# TRANSYLVANIA COUNTY DEPARTMENT of PUBLIC HEALTH ON-SITE WASTEWATER DISPOSAL APPLICATION

Permit #: 09-055

TRANSYLVANIA COUNTY DEPARTMENT OF PUBLIC HEALTH IMPROVEMENT PERMIT DIAGRAM

File Name: Wagner, Richard & Kathleen Permit No.: 09-055 PIN: 8581-79-2539-000

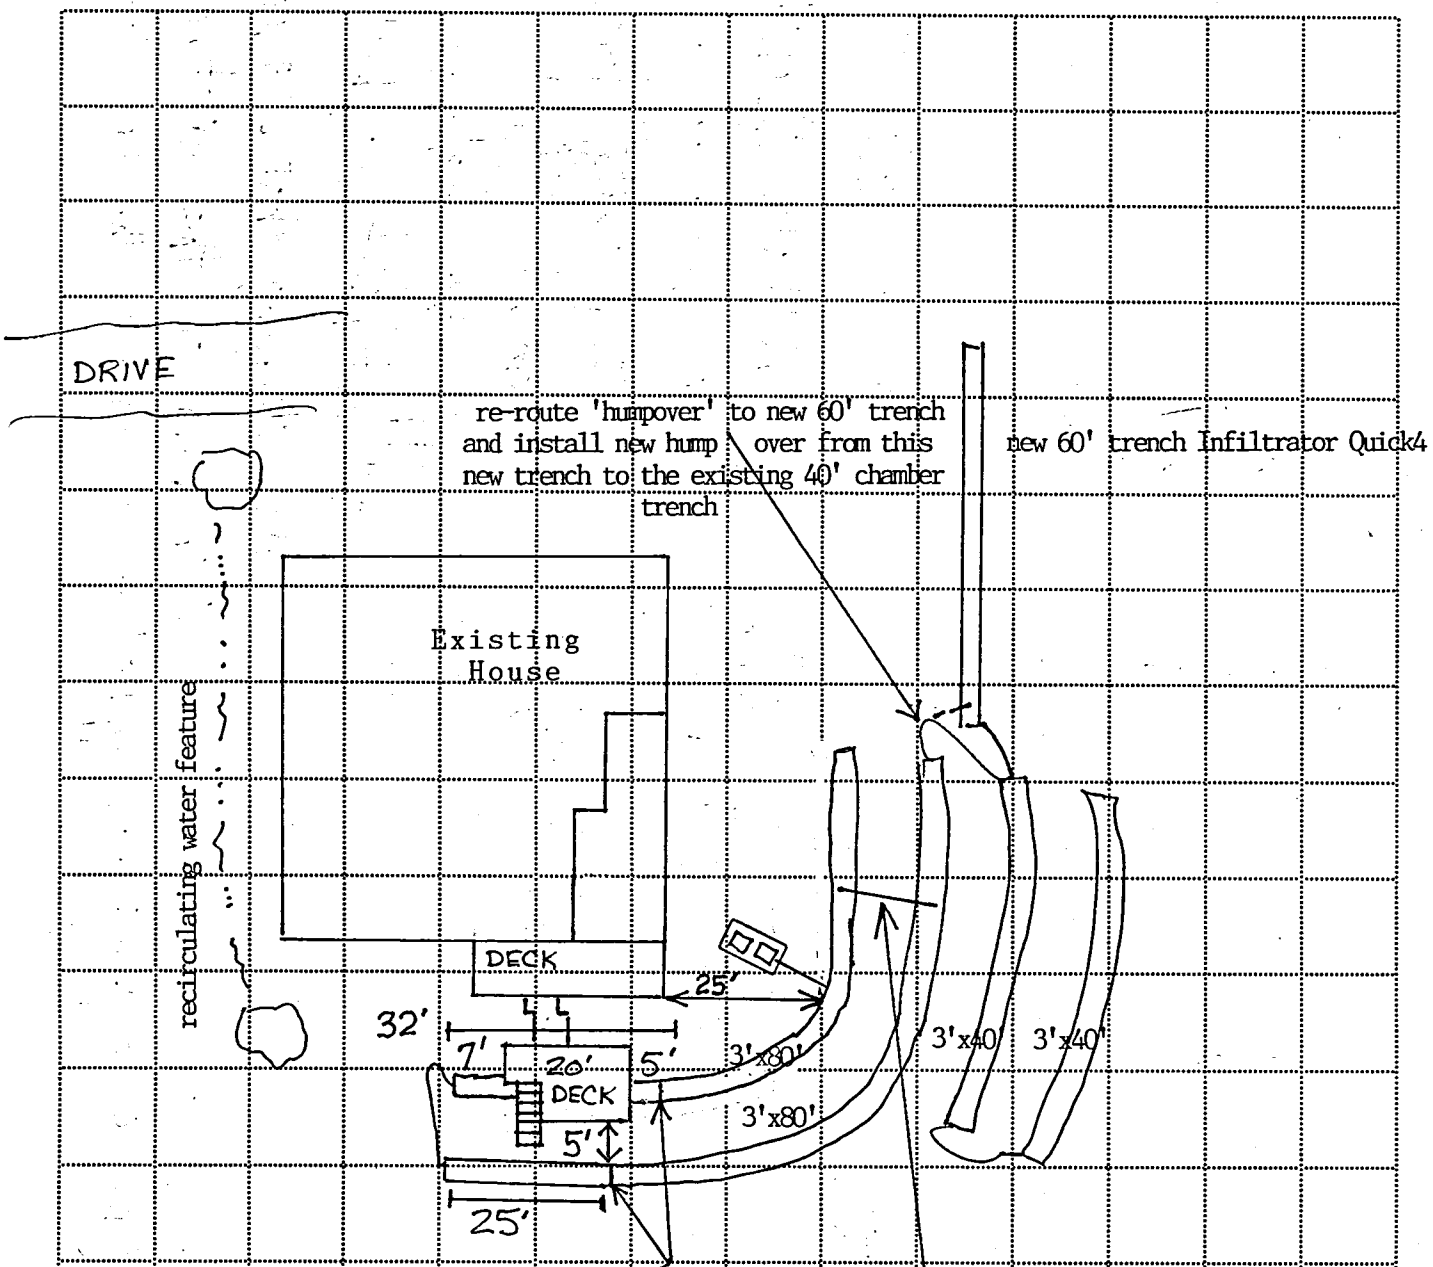
these two existing trenches terminated to meet setbacks

A new 60' (15 chambers) Infiltrator Quick4 trench was installed to compensate for the removal of part of the upper two trenches which did not meet setbacks to the new decking that was constructed over part of the existing drainfield-

install two new end caps where these existing trenches will terminate 5'+ off the new decks which were installed without a permit and over the existing drainfield. approximately 32' of the upper trench and 25' of the second trench will be disconnected from the existing system to meet setbacks; therefore, a 60' trench is to be installed as shown to make up the difference.

where the existing, upper trenches are terminated, the chambers must be removed at the end of the trenches (at least one 4' chamber in each trench) and the soil compacted with a clay soil at least two feet past the newly installed end caps in order to keep the trenches from short circuiting into the old trench lines.
